IMPERIAL COMMUNITY COLLEGE DISTRICT
IMPERIAL VALLEY COLLEGE
PARKING LOT RENOVATION

ADDENDUM #02

THE FOLLOWING ITEMS ARE LISTED AS CORRECTIONS OR CLARIFICATIONS TO THE CONSTRUCTION DOCUMENTS.

Document Date	Project Number
2026-10-09	26-11IV
Date Last Revised: 1 2026-11-06	Sheet Number: AD-2_AS5.3

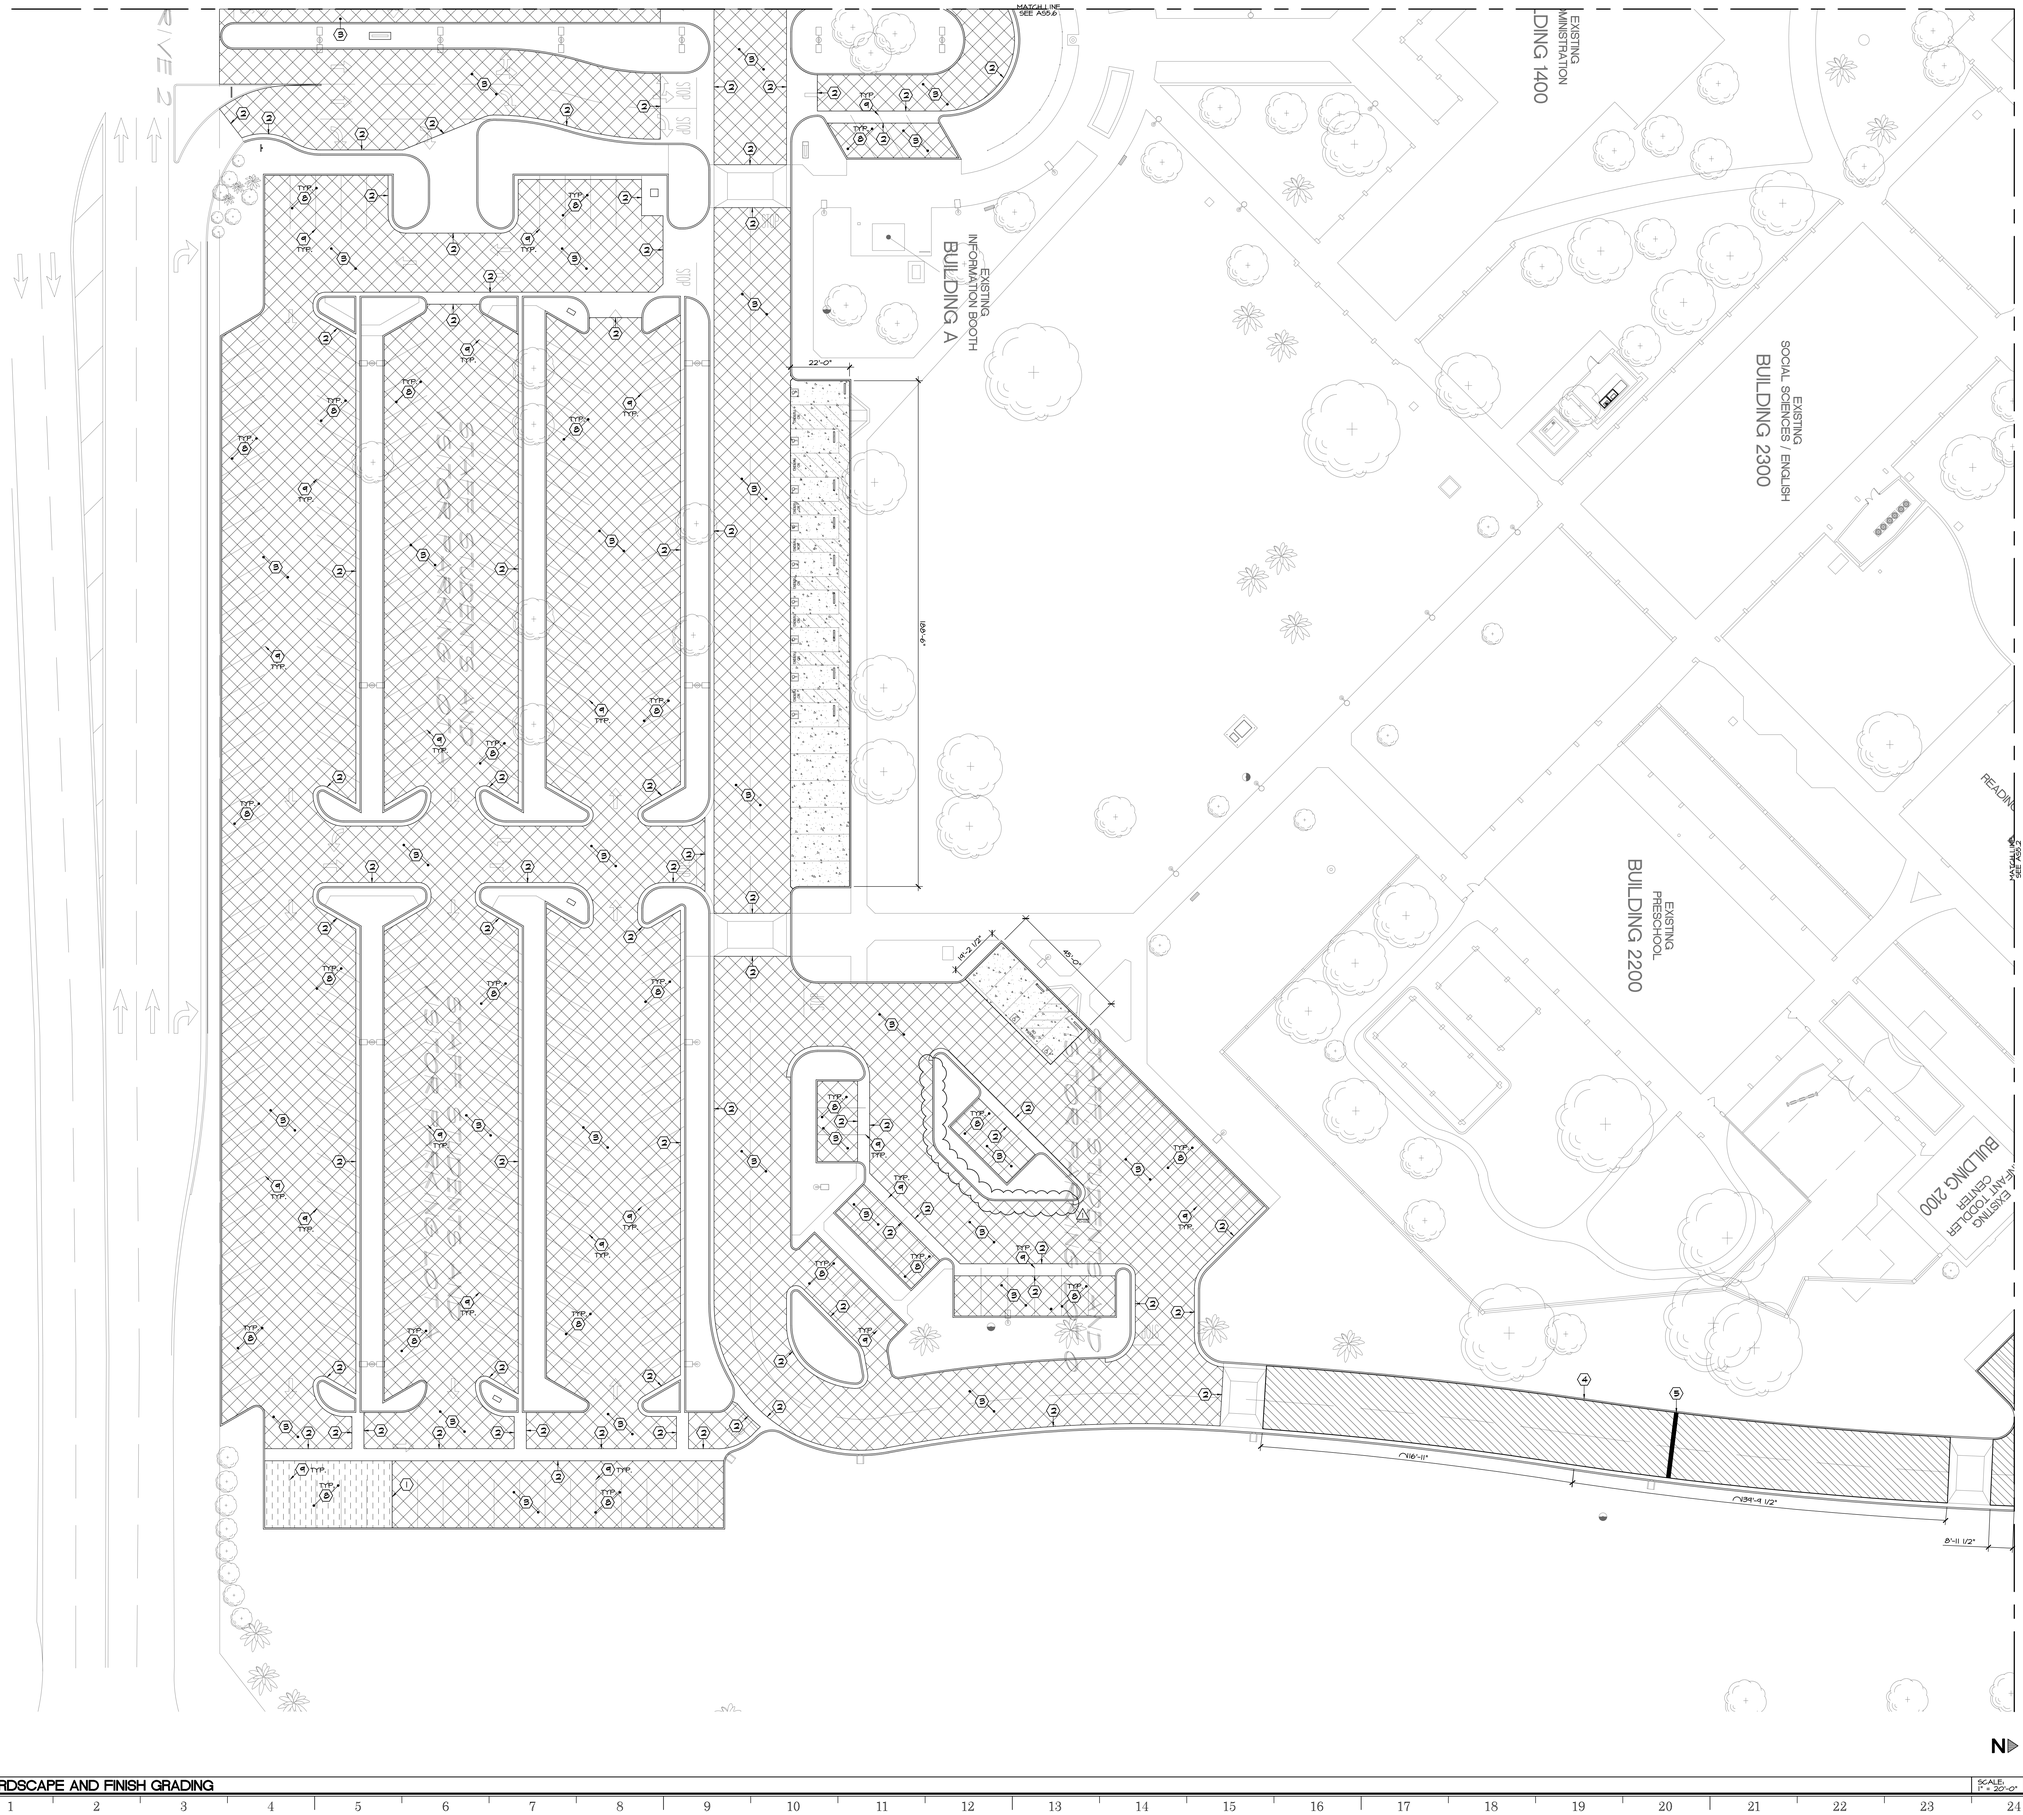
B. CLARIFICATION
    1. Total linear feet for Keynote 2, “Grind existing AC paving adjacent to concrete curb/hardscape as required for smooth transition”, on sheets AS5.3, AS5.6 and AS5.7 is 4,260’.

1. AS5.3 – HARDSCAPE AND FINISH GRADING
    a. Sheet AS5.3 shall be replaced by Sheet AD-2_AS5.3 attached to this addendum. All changes have been clouded.

Document Date	2026-10-09
Date Last Revised	2026-11-06
Project Number	26-11IV
Sheet Number	AD-2_AS5.6

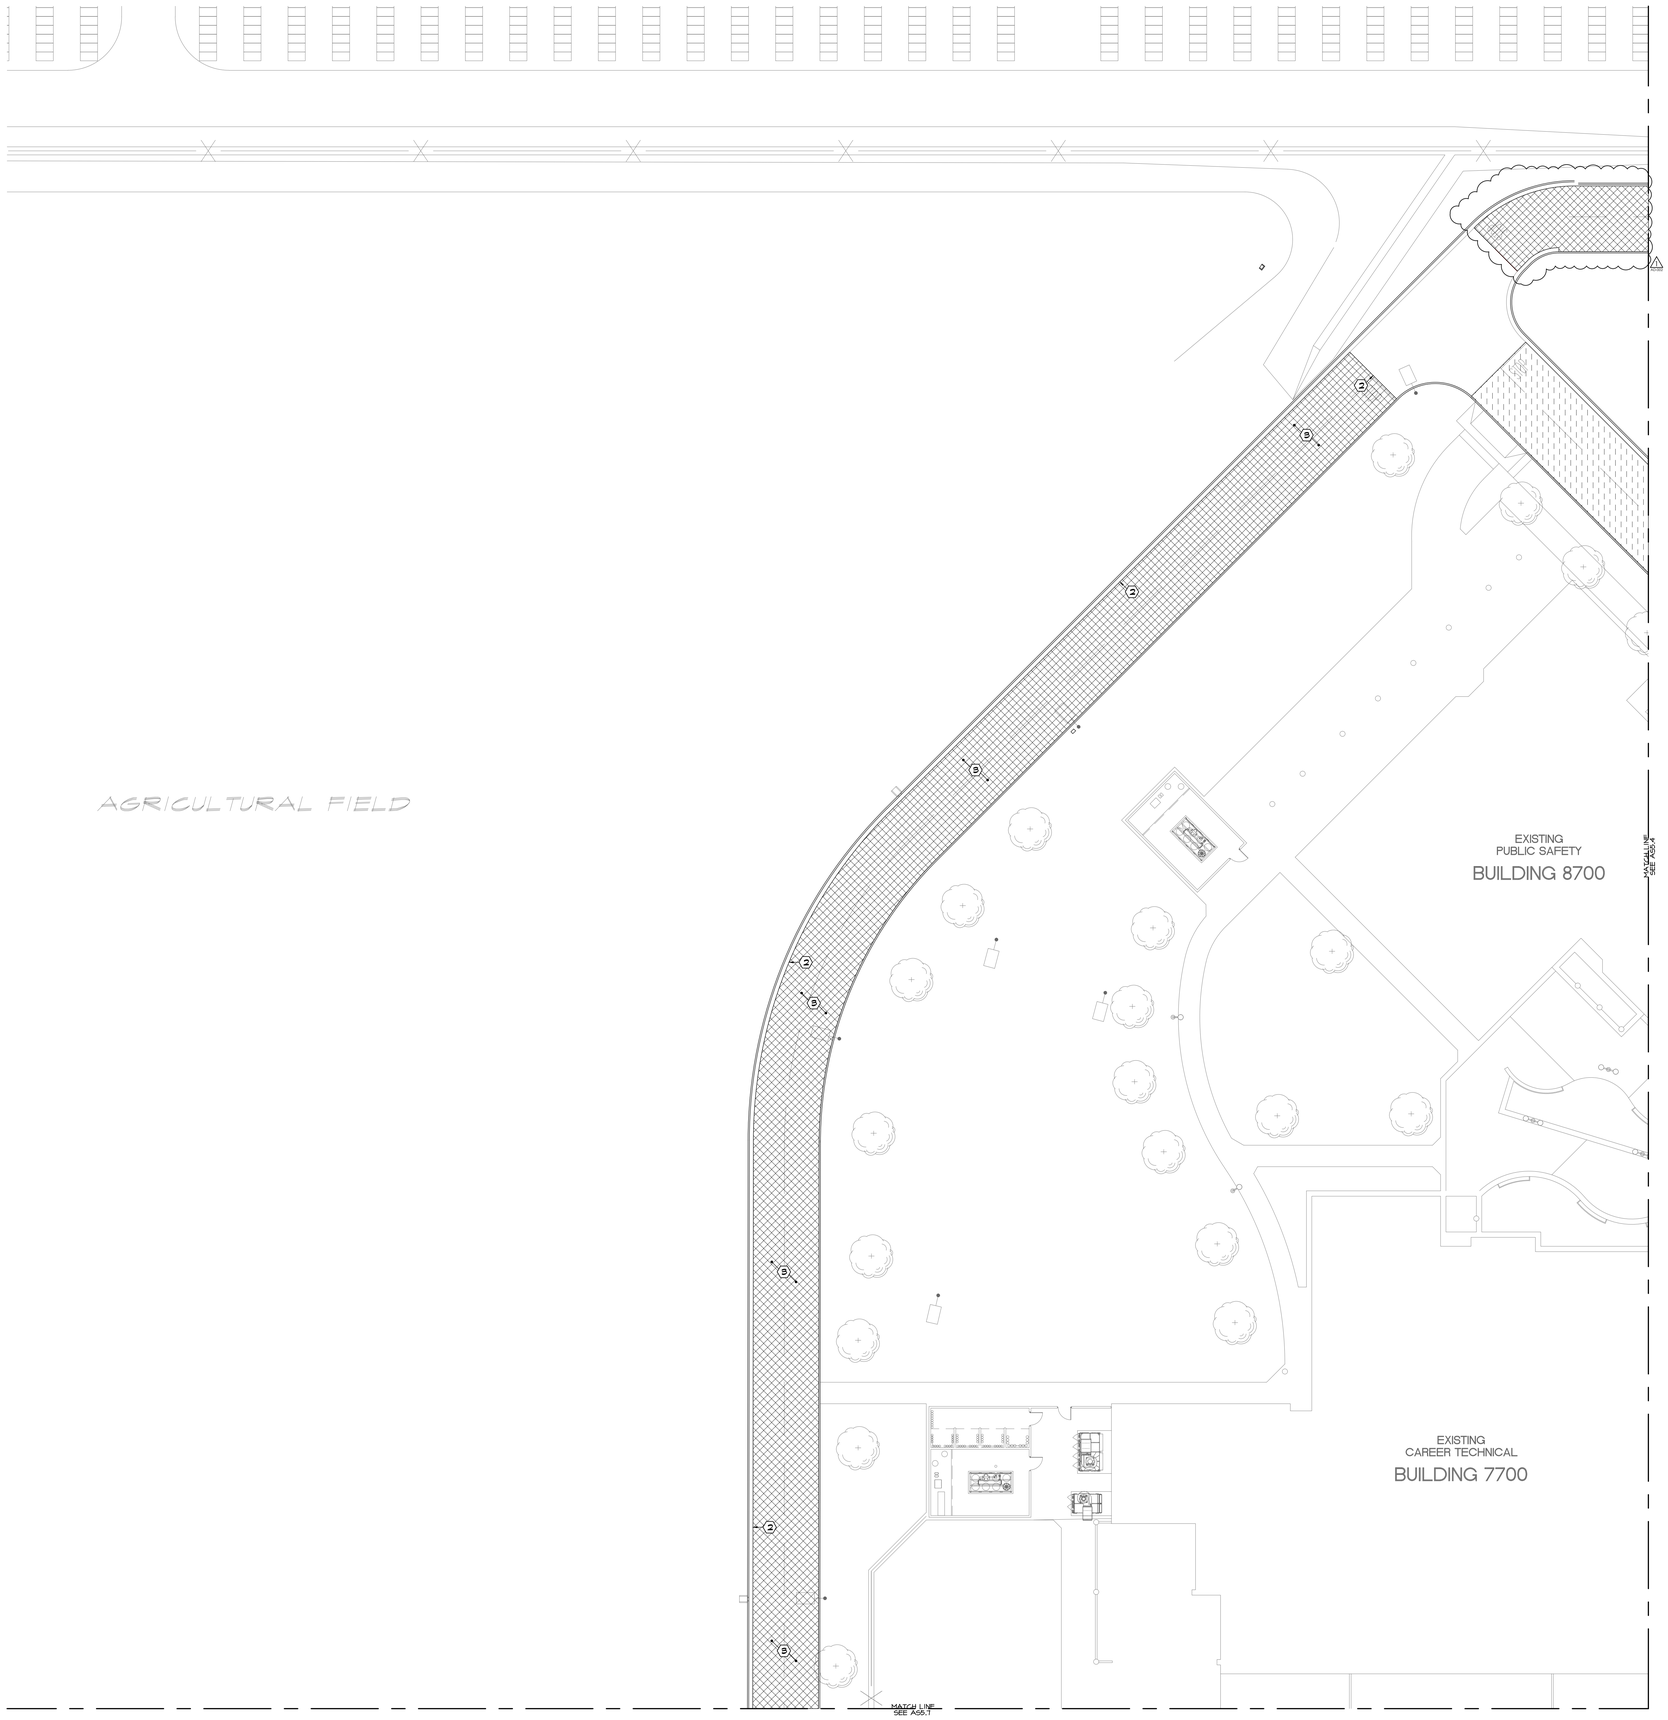
2. AS5.6 –SITE UTILITIES PLAN
    a. Sheet AS5.6 shall be replaced by Sheet AD-2_AS5.6 attached to this addendum. All changes have been clouded.
